Responses to Comments – Individuals

SUBJECT: Formal Comments for SDSU DEIR (4/21/17)

Response to Comment Letter I75

Housing Masterplan

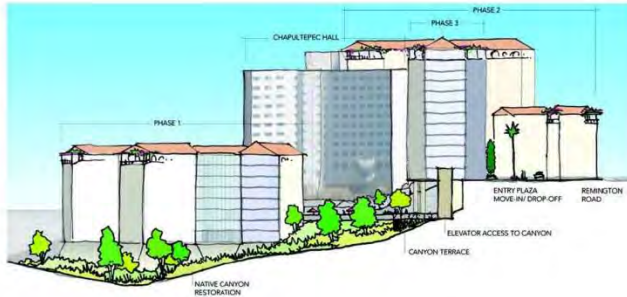
I158-4
Cont.

I158-4
Cont.
